PIC16F88X Family Silicon Errata and Data Sheet Clarification

The PIC16F88X family devices that you have received conform functionally to the current Device Data Sheet (DS41291G), except for the anomalies described in this document.

The following typographic corrections and clarifications are to be noted for the latest version of the device data sheet (DS41291G):

FIGURE 1: SCK PULSE VARIATION USING TIMER2/2

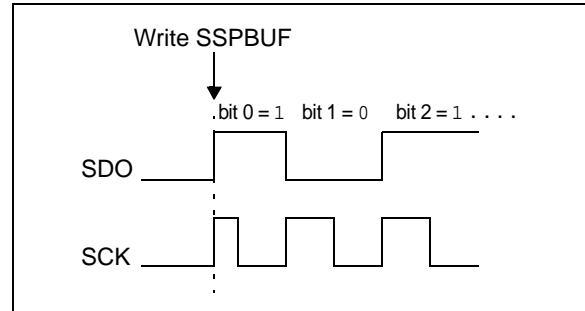
When the SPI is using Timer2/2 as the clock source, a shorter than expected SCK pulse may occur on the first bit of the transmitted/received data (Figure 1).

To avoid producing the short pulse, turn off Timer2 and clear the TMR2 register, load SSPBUF with the data to transmit and then turn Timer2 back on. Refer to Example 1 for sample code.

FIGURE 3: ACTUAL (INCORRECT) OPERATION WITH CLOCK STRETCHING – EXAMPLE 1

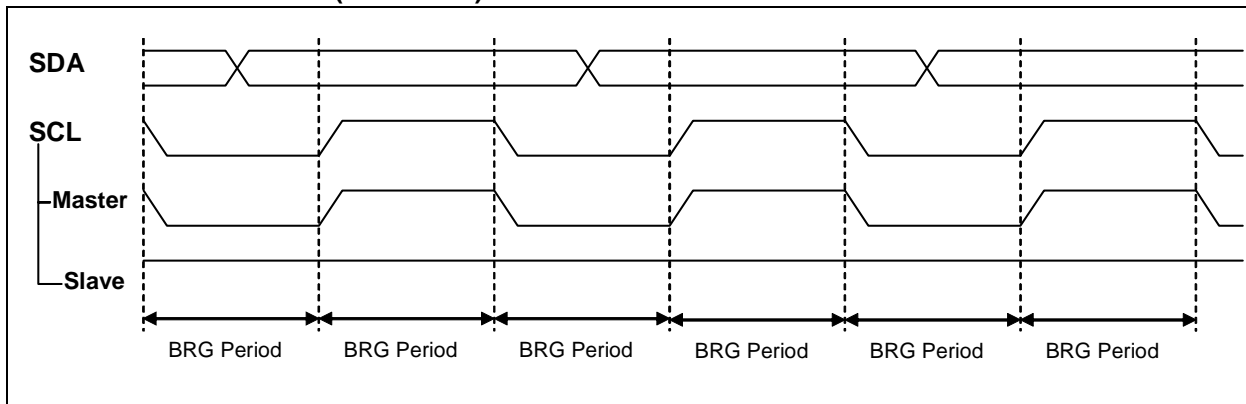
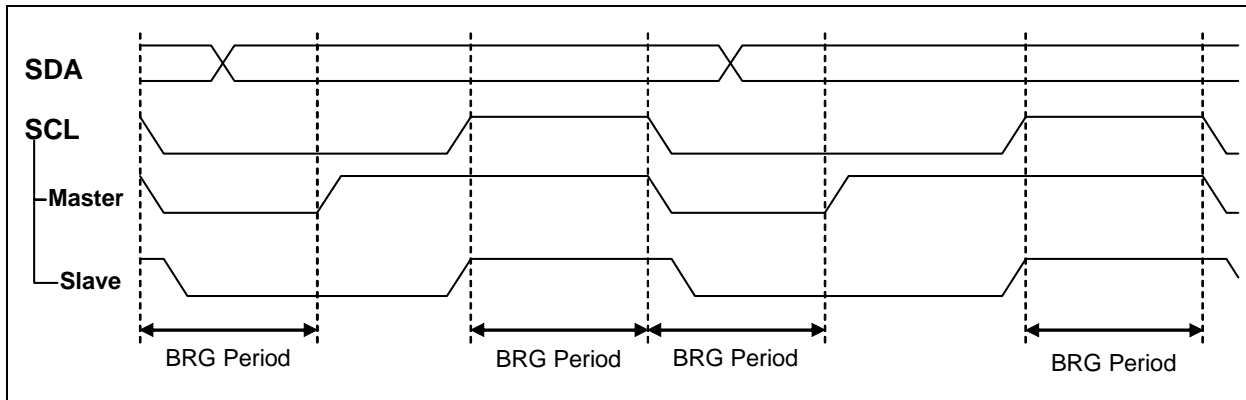
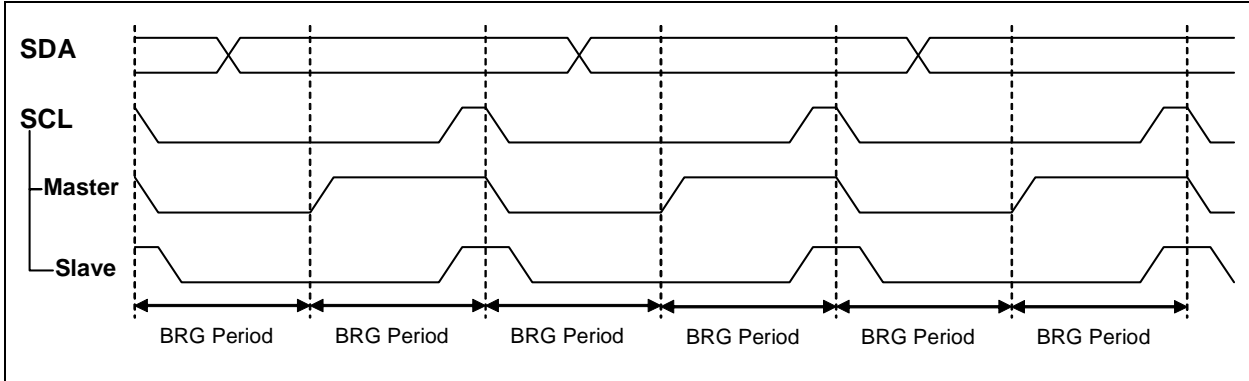
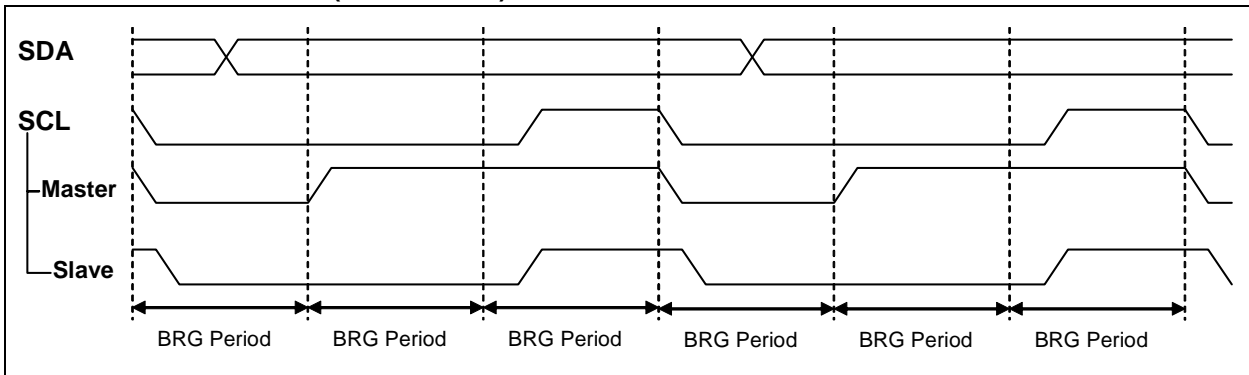
When the MSSP is I²C™ Master mode with a slave device stretching the clock, the clock generation does not function as described in the data sheet.

The current implementation does not ensure accurate SCL high time. During clock stretch, the MSSP device will erroneously continue running the BRG counter. At the end of the clock stretch, the BRG counter continues to count down for the

remainder of the BRG period, and then the MSSP device will immediately resume transmitting the data.

Figure 3 and Figure 4 illustrate an actual I²C transmission in which the slave has stretched the clock period by holding the SCL line low. Note that the high time of the SCL signal has shortened from the expected time.

Set the communication speed to match the slowest device on the bus. This ensures that no slave device will perform clock stretching.

It is possible to dynamically adjust the communication speed to match the device being addressed by modifying the BRG register. However, the behavior of slower slave devices must be understood and speed adjustments made such that no slave performs clock stretching.
